IN THE DRAWINGS

REMARKS

Figure 18

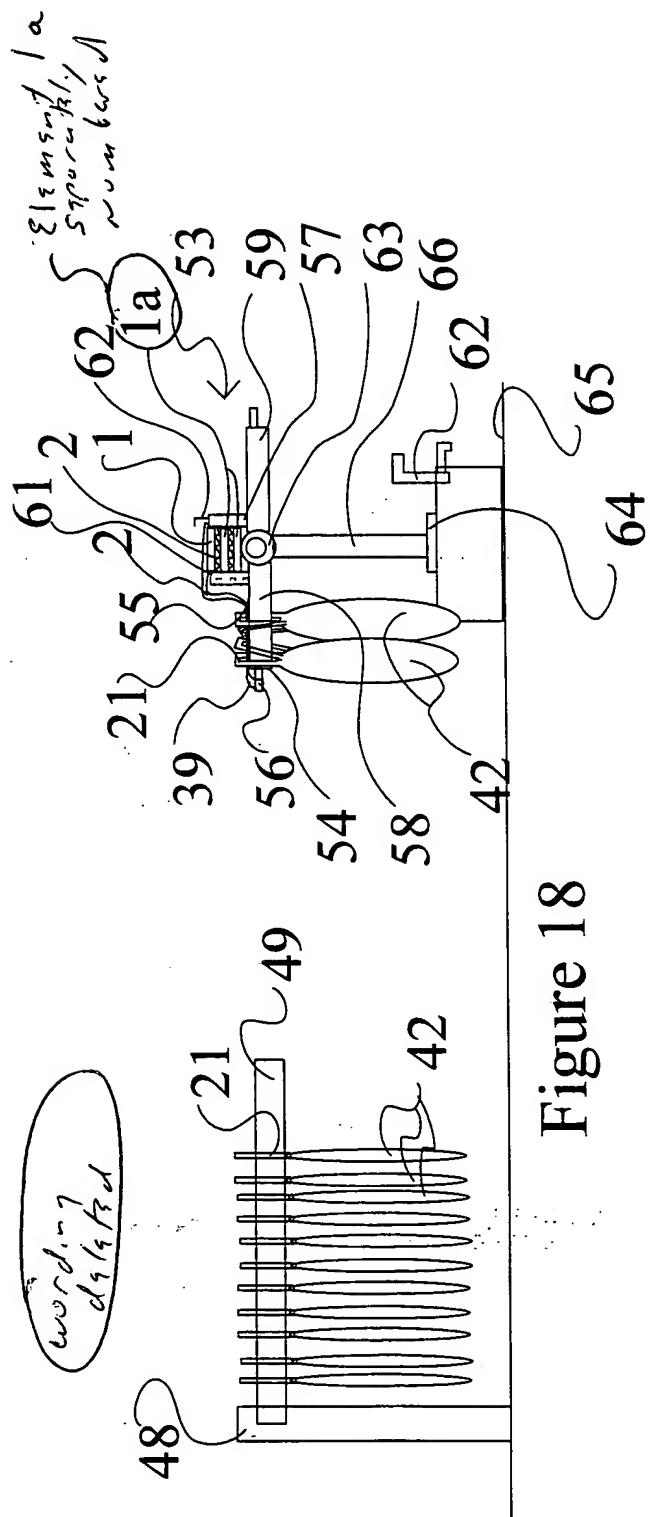
The prior art designation has been removed from figures 18 and 19. A new figure has been added, Figure 20, which shows the part of the prior two figures which was prior art.

Figure 18 has been edited to more clearly designate the handles and straps 1a below the first handle and strap 1. These are shown and described in the specification (see page 8 line 10, page 8 line 23-page 9 line 5, for example) and are clearly shown on the original figure 18, although for clarity they are separately numbered.

The primary aspect of the invention is its design in order to hold both bags and straps by the bag handle being over the strap. This is shown in Figure 18, showing the essential elements in the amended claim 11 which include a strap held on an arm for receiving the bag handles 21.

The Specification has been changed to point out where in the existing drawings the portions which were unclear are shown by renumbering those parts, mainly on Figure 18. Also, Figure 20

Figure 19

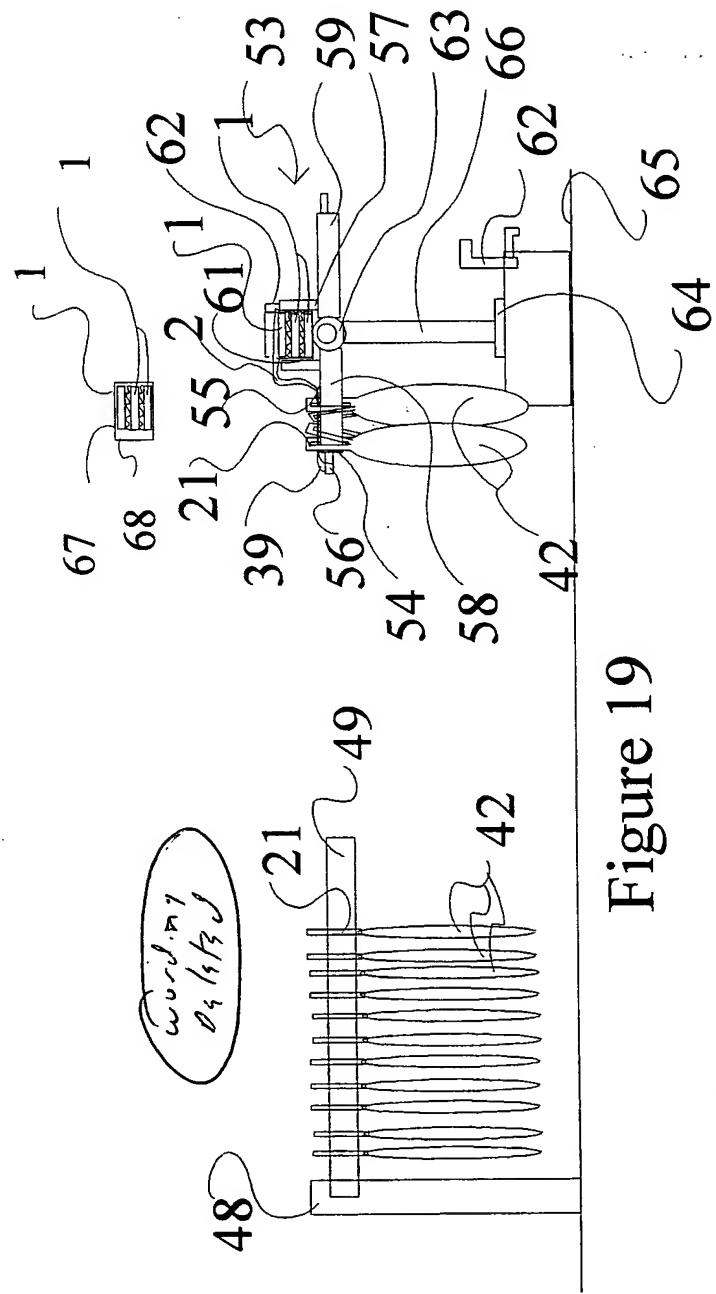
Yet another difference between the embodiment shown in Figures 18 and 19 is having a means for dispensing more than one strap, the same being shown as item 61 and 62. There is also no holder in the prior art for dispensing a plurality of straps.

Figure 20

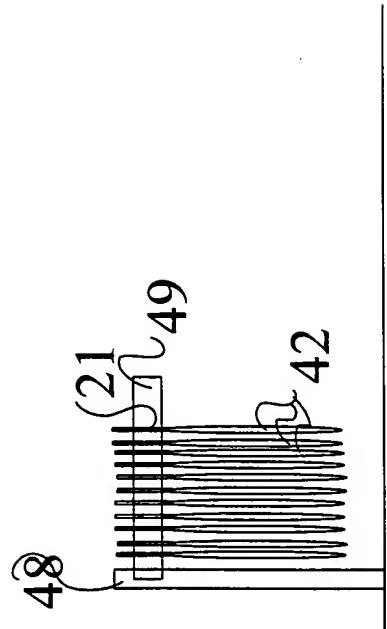
That has been corrected by adding the new figure, Figure 20 which shows the prior art bag dispensing mechanism.

Perhaps the most striking difference lies in the failure to provide a strap means juxtaposed with the bag loader and dispenser of the type shown in the prior art (New Figure 20) and shown in conjunction with Figures 18 and 19.

is added to show the portion of Figure 18 and 19 which was prior art and to distinguish the fact that only that portion of Figures 18 and 19 was prior art and that Figures 18 and 19 show a new invention. Nothing new is added to the drawings and no new matter is added.
